ACSF-C CV
**Proposal for a supplement to 03 and 04 series of amendments UN-R79 (to
replace/amend ECE/TRANS/WP.29/GRVA/2021/11)**

Amendments to the current text of the regulation are indicated in bold characters for new text and strikethrough for deleted text

5.6.4.8.2. **Detection area on ground level**

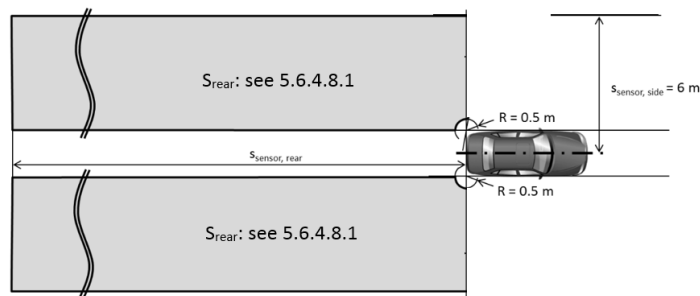
Paragraph 5.6.4.8.2., amend to read:

The vehicle system detection area on ground level shall be at minimum as shown in the figure below.
